SUBJECT: U.S. NUCLEAR REGULATORY COMMISSION (NRC) APRIL 19, 2010 ONSITE
OBSERVATION REPORT FOR THE SAVANNAH RIVER SITE SALTSTONE
FACILITY

**U.S. NUCLEAR REGULATORY COMMISSION (NRC) APRIL 19, 2010 ONSITE
OBSERVATION REPORT FOR THE SAVANNAH RIVER SITE SALTSTONE FACILITY**

Figure 1: Disposal Cell Depiction (not to scale)

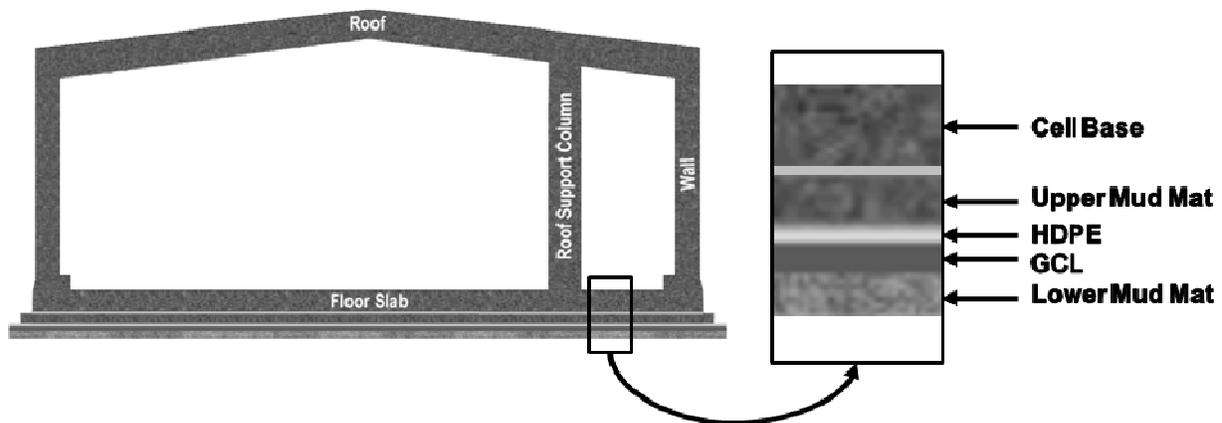
The staff's visit was prompted initially by an interest in observing the hydrostatic test of disposal cell 2B, however, shortly before SRR began the test, multiple damp spots were evident at points

around the base of the cell (Figure 1). Due to the presence of damp spots on cell 2B, the hydrostatic test of cell 2B was postponed and investigations were performed to determine the source of the spots.

The NRC staff visited the site to observe the progress of examining the root cause of the damp spots. At the time of the observation, the vendor CROM was in the process of removing the outer layer of shotcrete on the outside base of the cell at the points exhibiting damp spots. In addition, spots noticed at a lower point (between the upper mud mat and the cell floor, note Figure 1) provided sufficient evidence for portions of the upper mud mat to be removed enough to see the circumference of the cell floor under the base of the cell. SRR staff walked NRC staff around the circumference of the cell and requested multiple photos be taken at various points during this portion of the tour (available at ADAMS accession number ML101460045). In all, 33 damp spots were identified at various spaces around the circumference of the cell. These spots were slightly damp to the touch, but were mostly evident by sight. NRC staff asked various questions pertaining to the timing of the damp spots and any correlations the location of the spots had with construction materials, components, etc. that might have been noticed by SRR or CROM staff. A question of note asked by NRC staff was what effect the presence of damp spots will have on the hydro-test procedures, specifically, will any chemical or visual tracers be used in future hydro-tests (e.g. cell 2A hydro-test). SRR staff responded to the question by saying that insertion of a tracer will be considered for the hydro-test of cell 2A. Damp spots are of interest to the NRC staff because their unexpected presence and the corrective actions to repair them could each have some effect on assumptions made in the performance assessment pertaining to vault performance.

A red dye tracer was then added to the water to distinguish between water inside the cell and water from the surrounding environment, outside the cell.

Based on the results of the visit and the preliminary results provided by DOE (ML101660516), the NRC continues to have reasonable assurance that the performance objectives of 10 CFR 61 can be met but continues to monitor the situation closely. The NRC staff will monitor the path forward and corrective actions considered and taken by DOE and its contractors regarding the damp spots found on cell 2B prior to the hydrostatic test. Prior to the observation, DOE provided the vendors hydro-test procedure (CROM, 2009). Photos of the tour of the facility that took place in lieu of observing the hydro-test are available in NRC's document repository, the Agencywide Documents Access and Management System (ADAMS), at ADAMS accession number ML100550095.

Shortly after this observation, SRR inserted a fluorescent red dye into the cell water as a visual tracer. After mixing the dye throughout the cell, pink stains were evident at the interface between the cell base and the upper mud mat. Since that time, SRR has been working to identify the mechanisms causing these potential flow paths and furthermore to identify corrective actions should they actually be flow paths. NRC staff will ensure that actions are taken during investigation or corrective action (e.g. construction repairs) will not substantially change the assumptions made in the PA (SRR, 2009) or that any change in the assumptions supporting the PA are accounted for in the NRC staff's review.
